**FINAL INTERIM REMOVAL ACTION WORK PLAN FOR THE OLD CONSTRUCTION
DEBRIS LANDFILL (SEAD-11)**

Army's Response to Comments from the New York State Department of Environmental Conservation

Subject: Draft Interim Removal Action Work Plan
Old Construction Debris Landfill (SEAD-11)
Seneca Army Depot
Romulus, New York

Army's Response to Comments from the US Environmental Protection Agency

**FIGURE 3-1
 SEAD-11
 PROPOSED LIMITS OF REMOVAL ACTION**

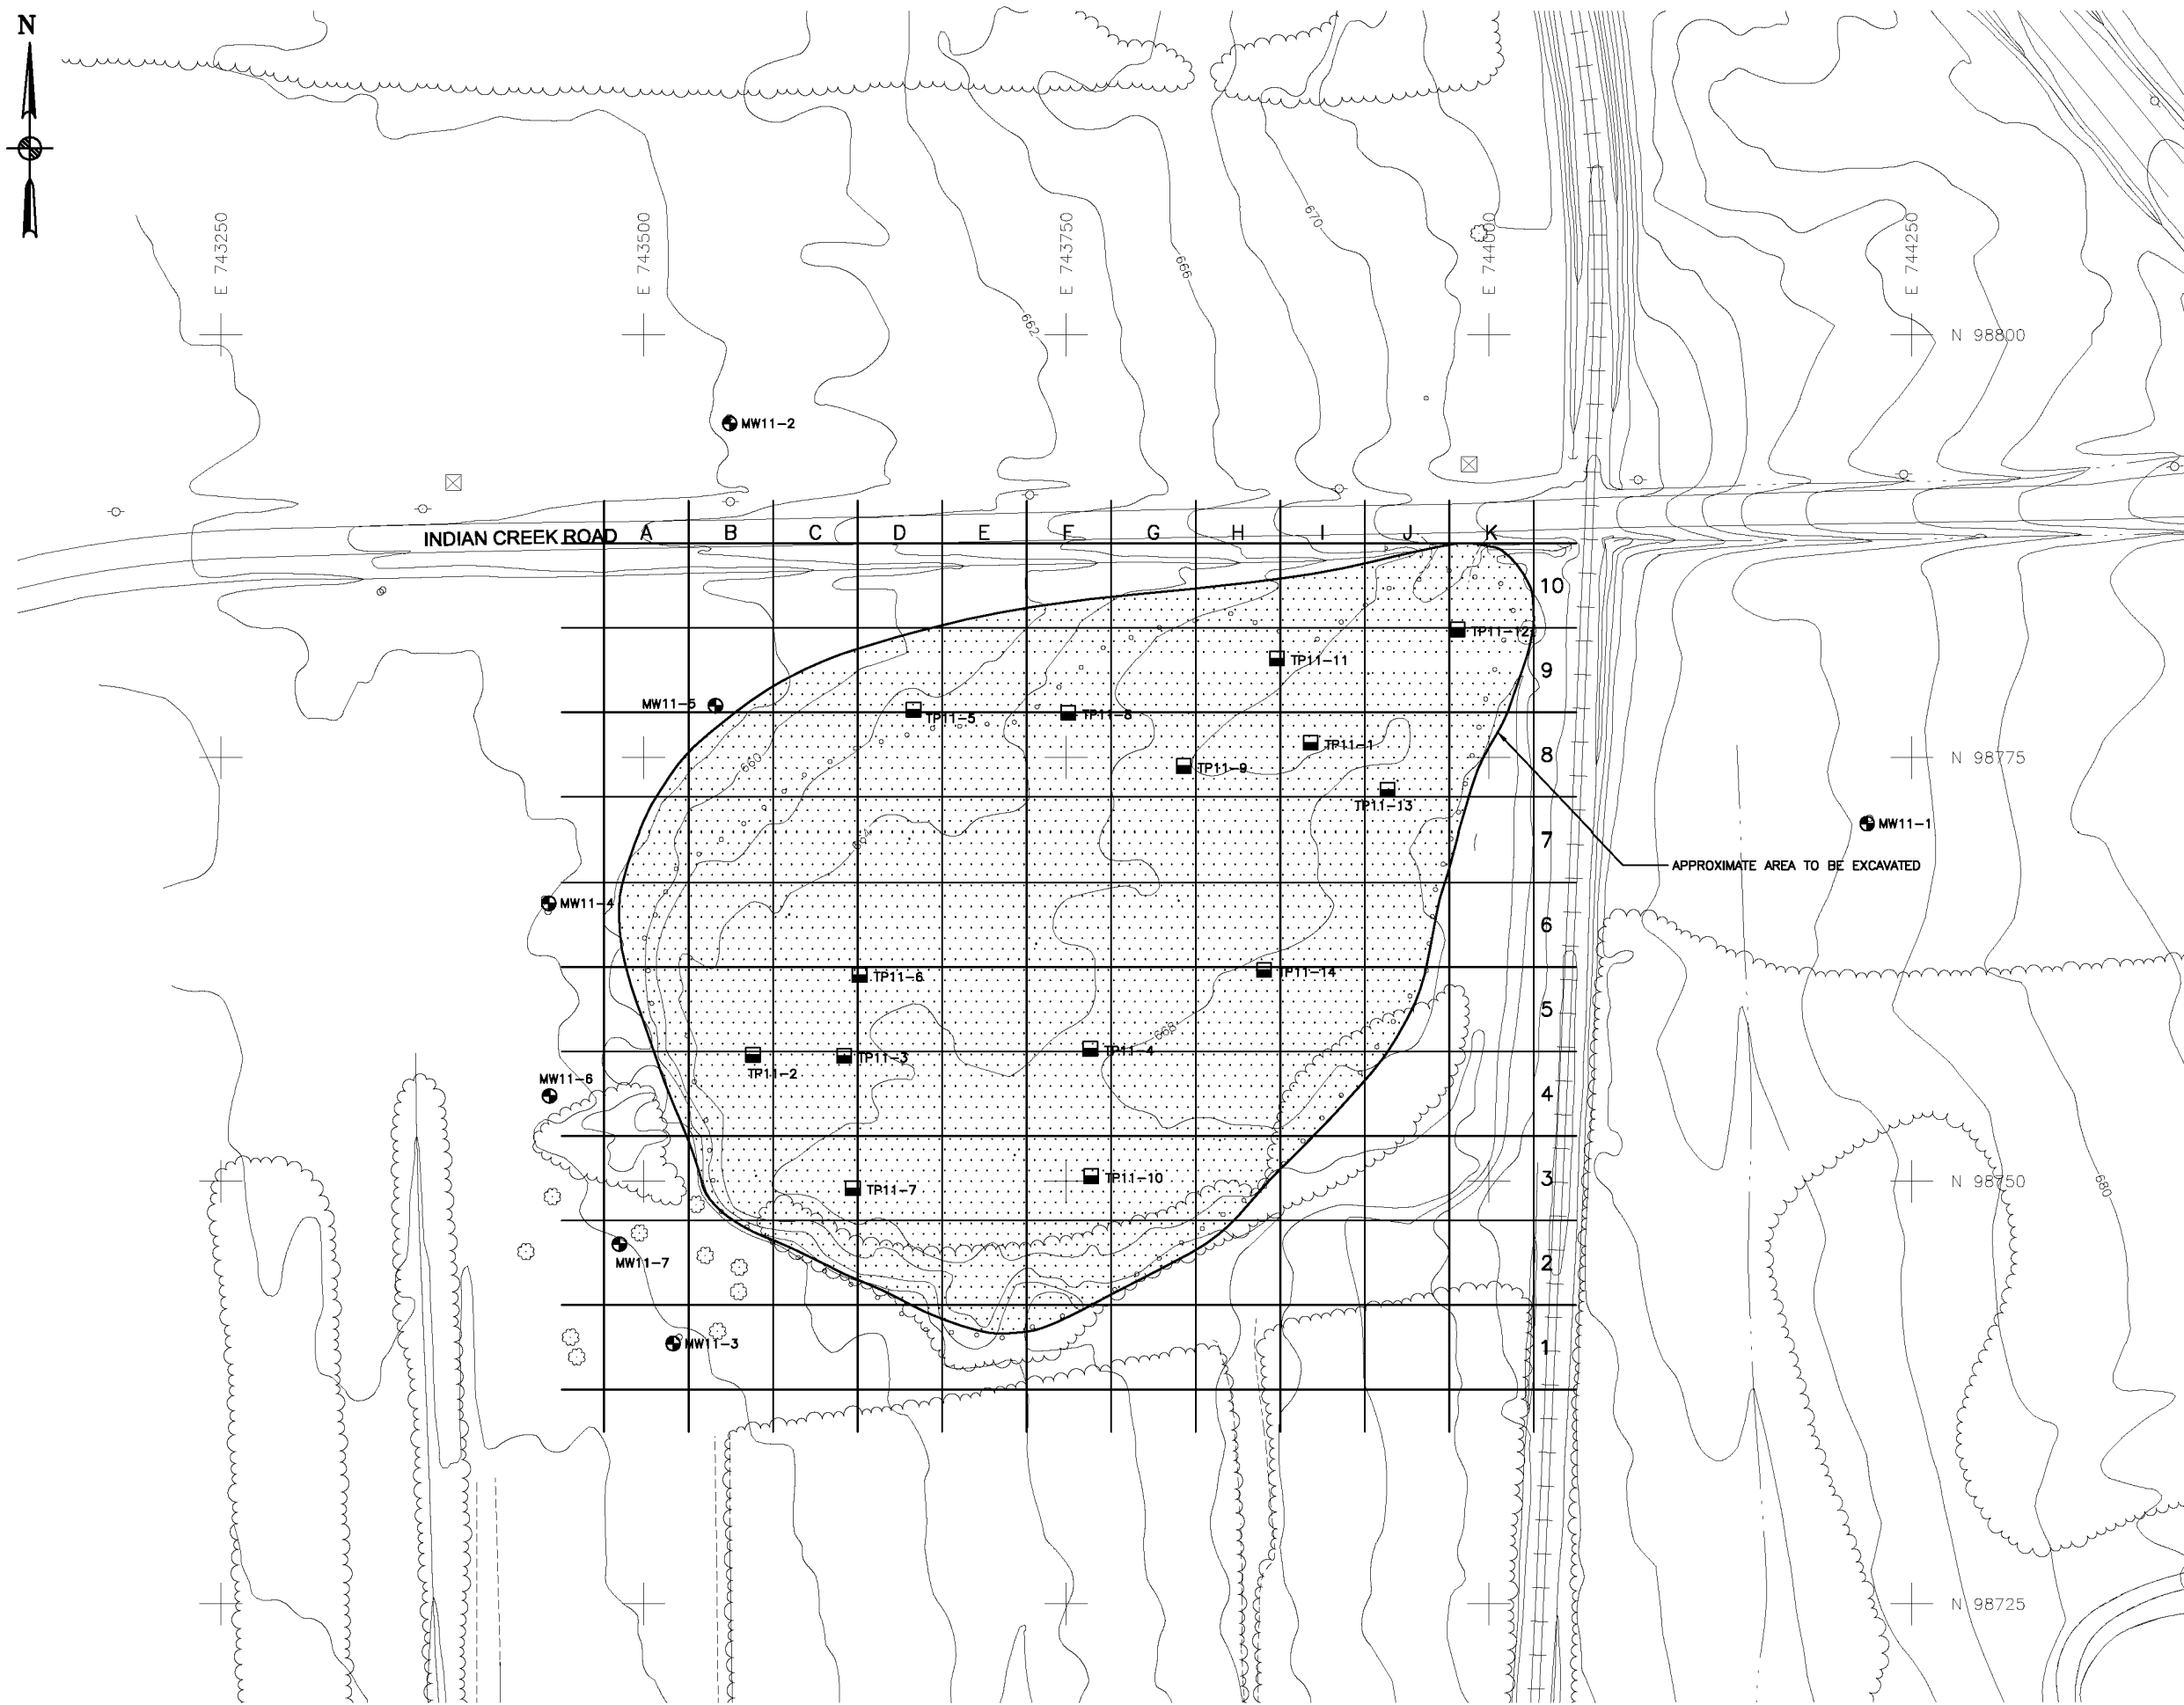
Comment 5: Section 3.1.6: Work and Staging Areas, Page 3-3. Although a general description of the proposed staging and work areas is presented in this section, a figure depicting the approximate locations of these areas (including entry/exitways, support zones, decontamination zones) should also be provided to show these areas in relation to one another and the excavation area. Please provide a figure that depicts the important staging and work areas.

Comment 6: Section 3.1.7: Control of Run-On and Run-Off Waters, Page 3-3. Diversion berms to divert run-on waters around the excavation will be constructed of clean soil, but the source of this clean soil is not clearly presented. If soil from the area surrounding the site is planned for use, the location of this soil should be identified to assure that it has not been impacted by landfill activities. Alternatively, if clean fill will be transported to the site, the source of this soil should be identified. Please provide further clarification on the source of the clean soil used to create diversion berms around the excavation.

Response 5: Figure 3-1 has been revised to include additional details. The staging/stockpile area will be located over material that will be excavated last. All stockpiling, staging, and decontamination activities will be performed here. Excavation will begin in the southwest section of the landfill and continue north

Response 6: Diversion berms will not be required. The excavation plan has been revised so that excavation will start from the most downgradient end (southwest end) and proceed north and east so that any water will either contact the current vegetated cover or its contact will be limited to previously excavated areas before migrating to downgradient areas. The Army will provide silt fence along the downgradient edge of the landfilled area to prevent sediment transport and check dams will be installed in the swale that runs along Indian Creek Road. A pipe will be added at the entrance and exit of the loading road (see Figure 3-1) as to not disturb the water flow in the swale.
